JLG 16076 Phillips Aquatics Community Center

RE: Addendum 5

## ADDENDUM #: 5

SHEET A612
INTERIOR ELEVATIONS

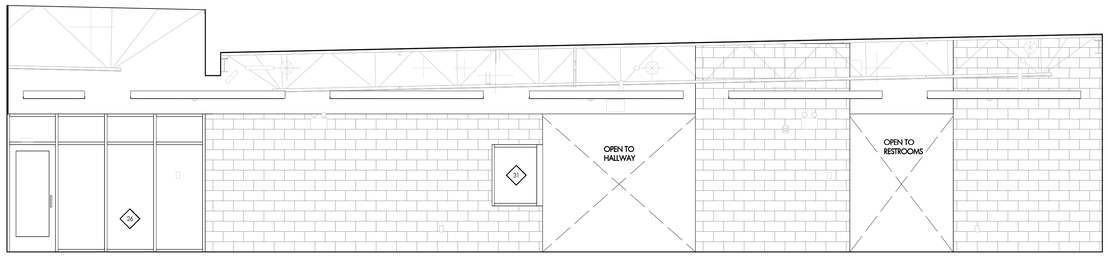
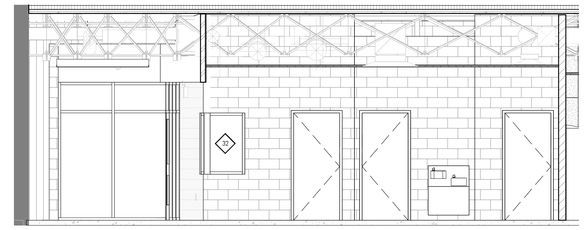
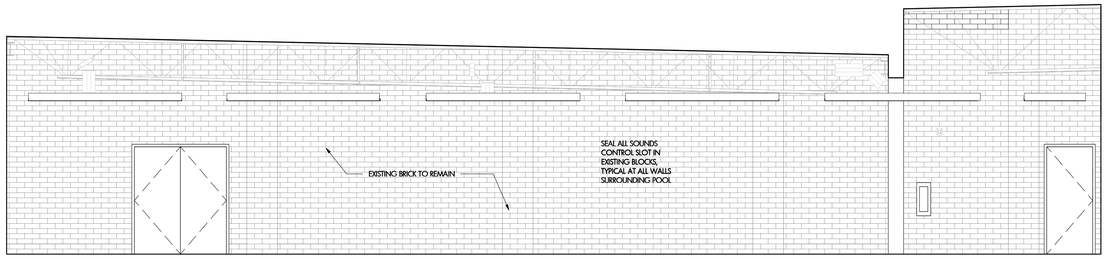
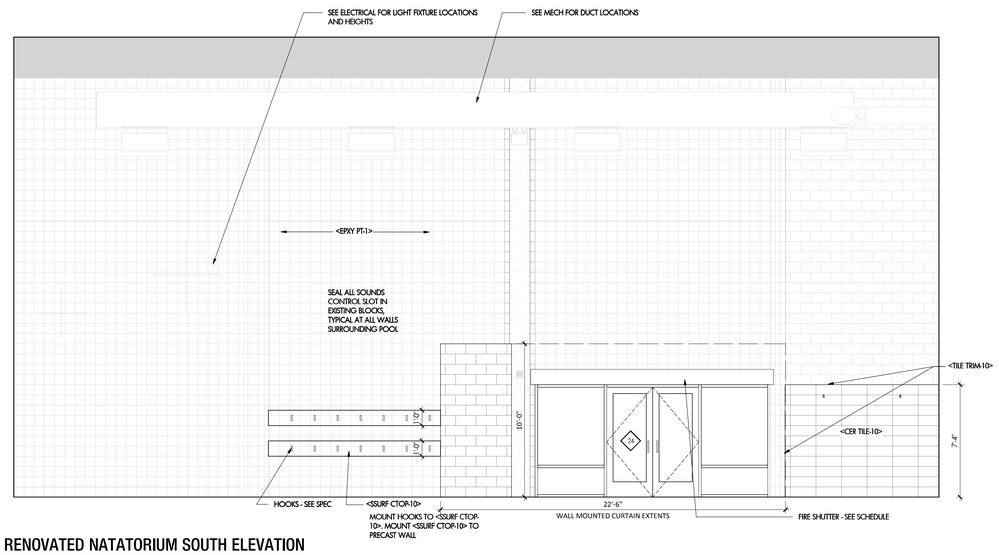
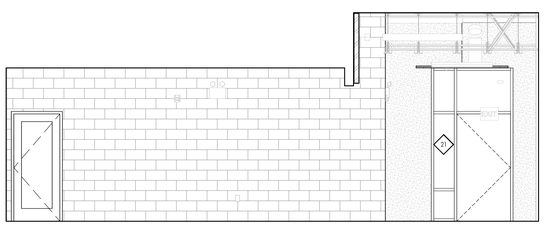
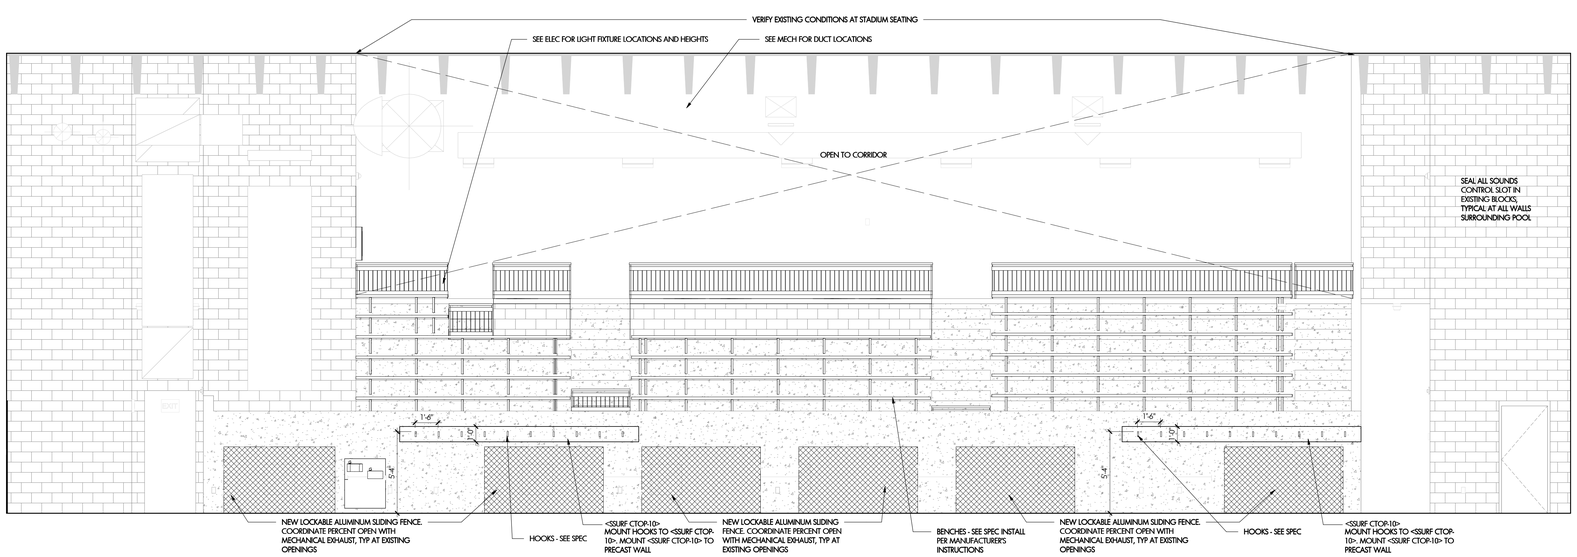
1. A612 – INTERIOR ELEVATIONS
   - Add hooks @ locations noted

DATE: 09.22.2016
PHASE: ISSUE FOR BIDDING
PROJECT: 16076
SHEET: A613
INTERIOR ELEVATIONS

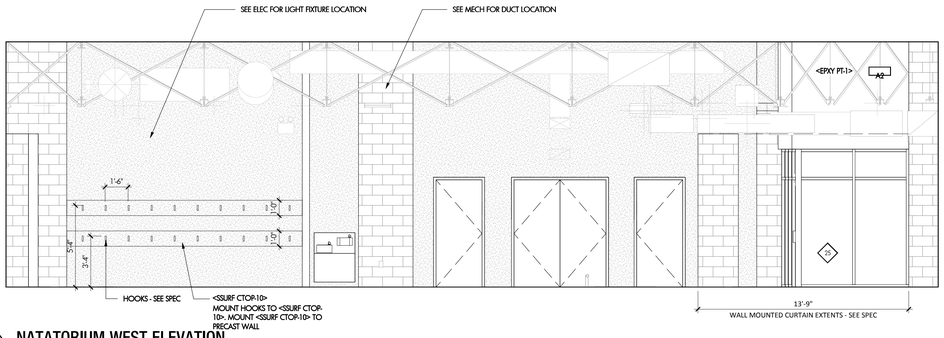
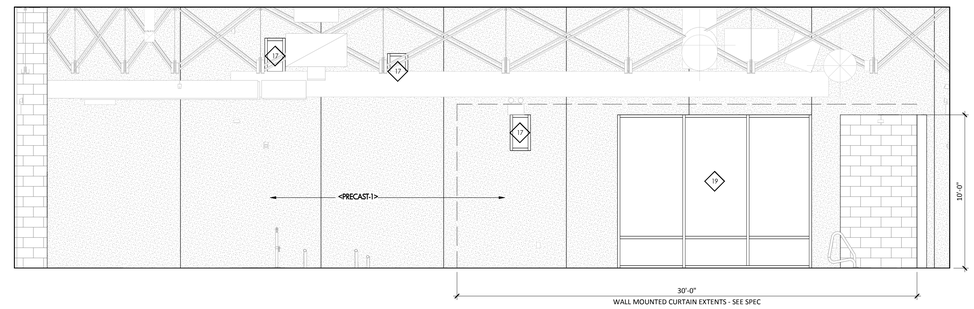
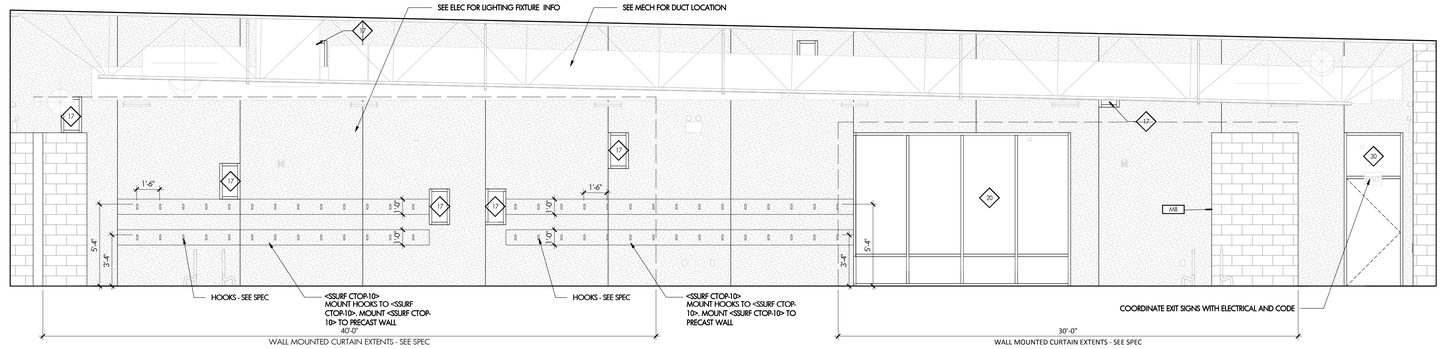
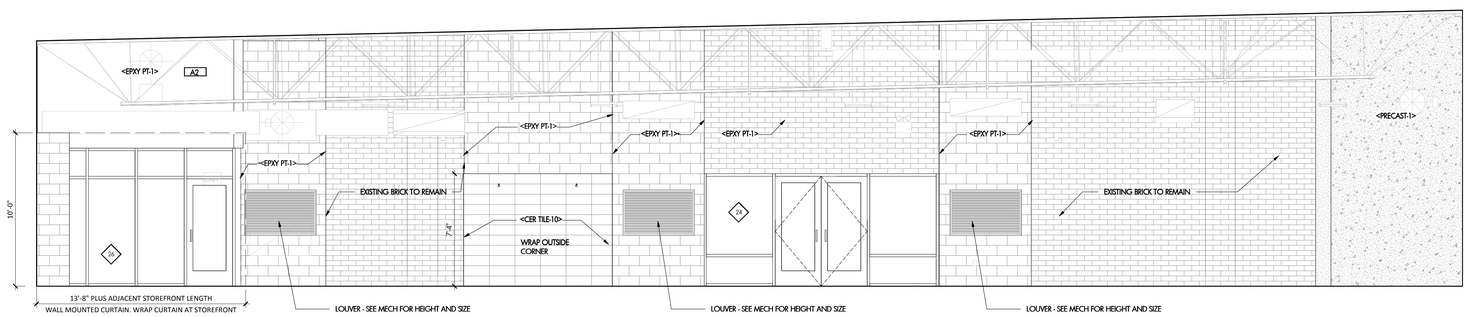
2. A613 – INTERIOR ELEVATIONS
   - Add hooks @ locations noted
